# SITE SERVICING AND SWM STUDY MEMORANDUM

SUBJECT: Proposed Amendment to 129 Main Street Site Plan Application  
City File Number: D07-12-10-0196

OUR FILE: DSEL Project No.15-813

**STORMWATER MANAGEMENT PLAN**  
**129 MAIN STREET**

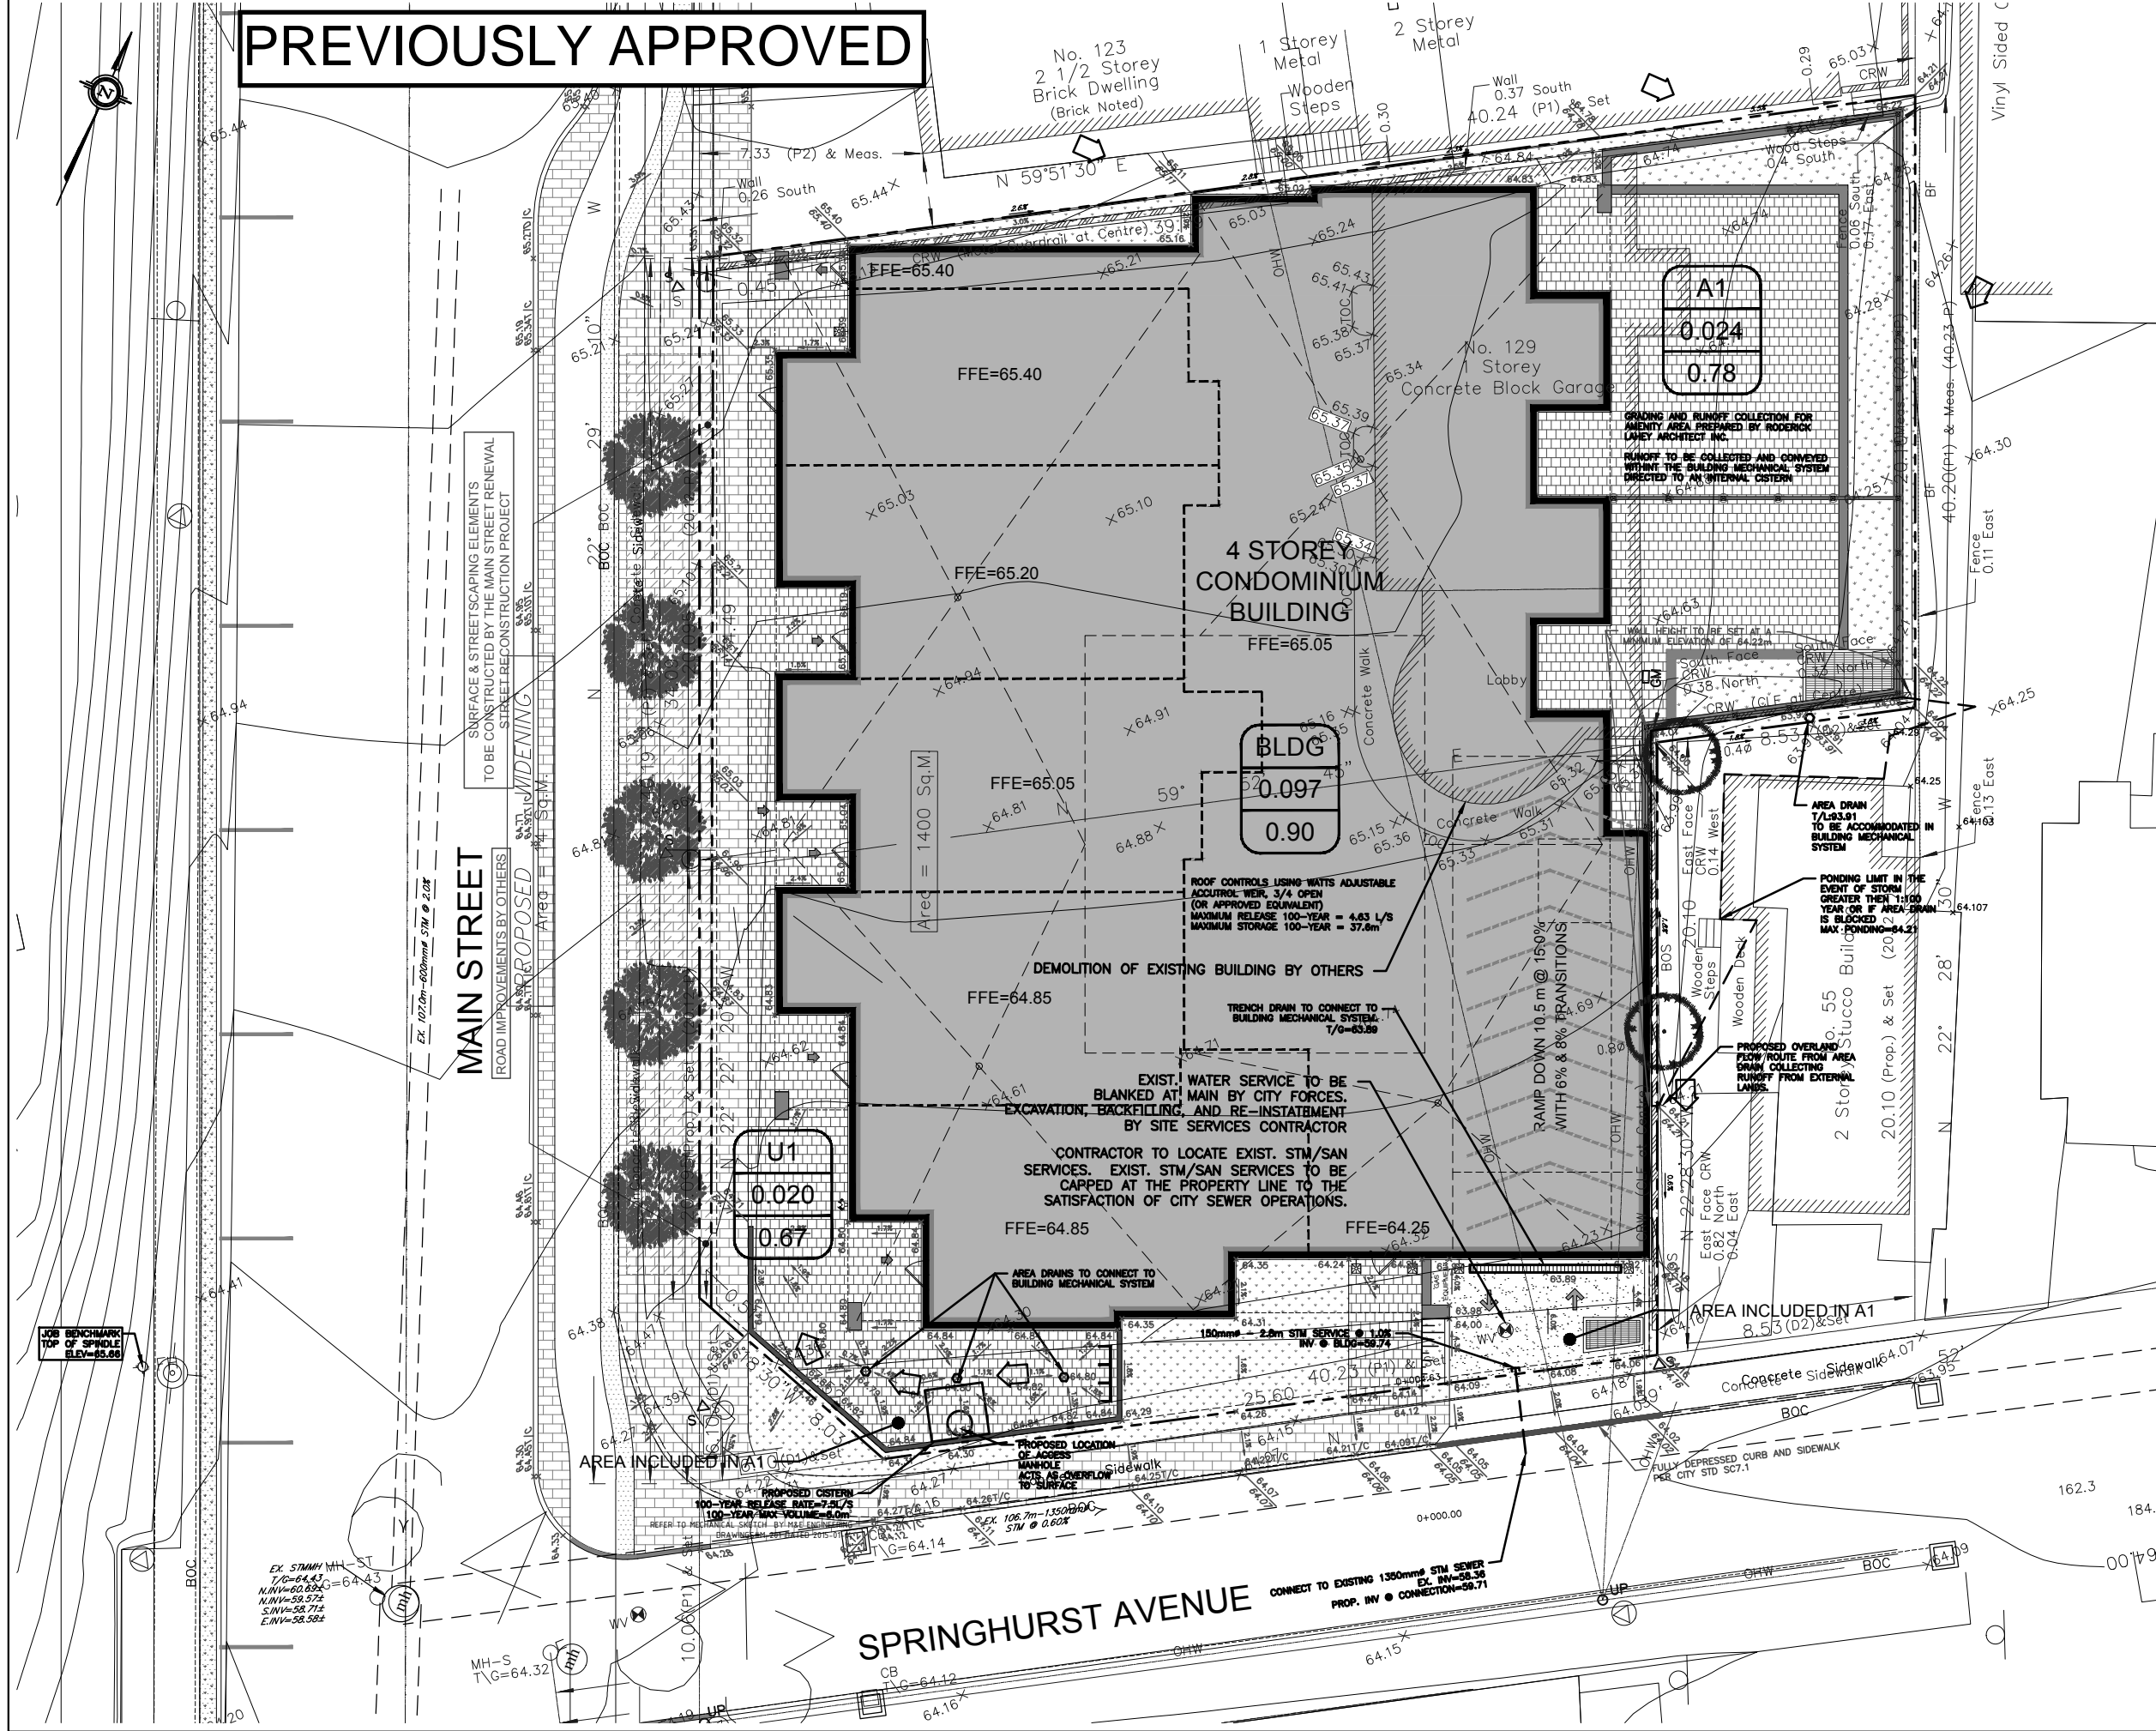
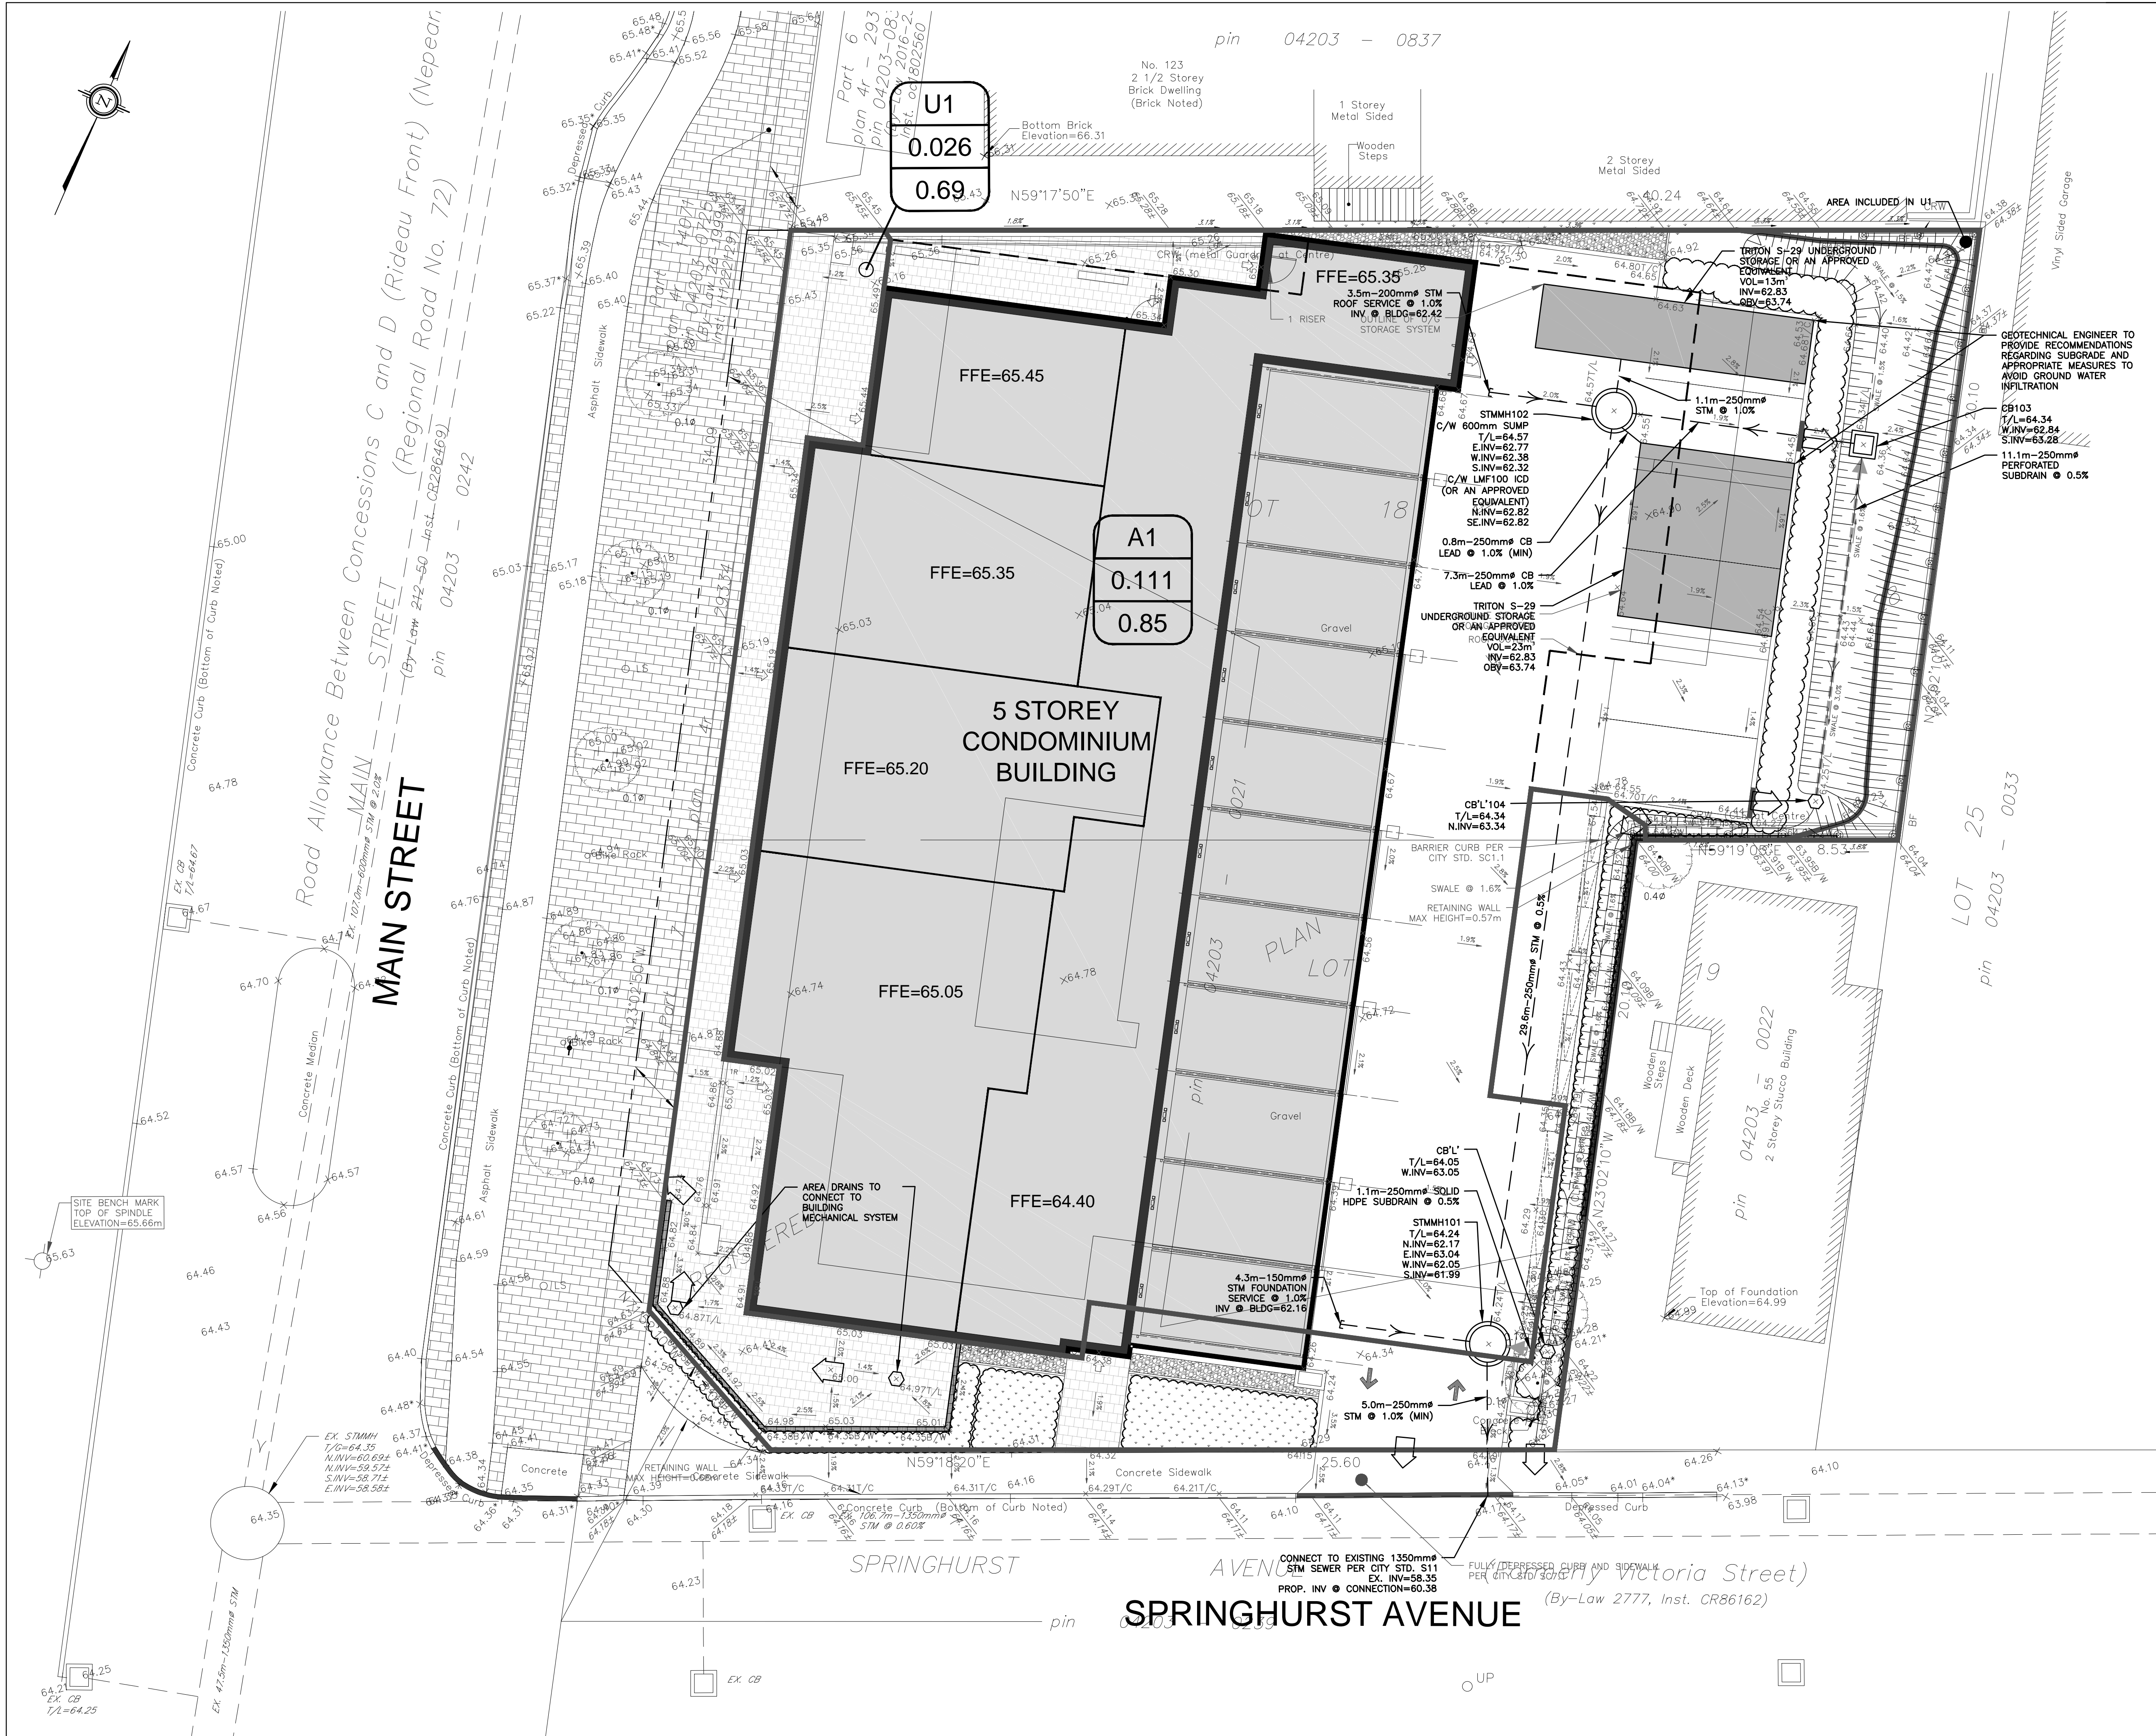
The previously approved storm calculation sheet and associated Stormwater Management Plan, **SWM-1** dated January 15<sup>th</sup>, 2016 is attached for reference. The established allowable release rate for the subject site was determined to be **20.4 L/s**; employing the City of Ottawa IDF parameters for a 5-year storm based on a rational method coefficient of 0.50 with a calculated time of concentration equal to or greater than 10 minutes for **0.14 ha** of the subject site.

Area A1, shown by drawing **SWM-1**, is tributary to the internal storm sewer connecting to Springhurst Avenue. A Triton S-29 underground storage systems or an approved equivalent storage system will provide **36.0 m<sup>3</sup>** of underground storage and stormwater flow will be attenuated by a Tempest **LMF90 ICD** at the outlet side of STMMH102. The attached storm calculation sheets illustrate the existing approved plan and proposed amendment. An updated **SWM-1** drawing dated December 2018 and calculation sheet is included in **Appendix D**.

Based on the revised calculations the established allowable release rate has been determined as **19.7 L/s**, employing the City of Ottawa IDF parameters for a 5-year storm based on a rational method coefficient of 0.50 with a calculated time of concentration equal to or greater than 10 minutes for **0.136 ha** of the subject site. The reduction in area is a result of the Main Street road widening limits.

Approximately **35.6 m<sup>3</sup>** of underground storage is required and will be provided via a **36.0 m<sup>3</sup>** Triton S-29 storage system, or an approved equivalent, to meet the established release rate of **19.7 L/s**.
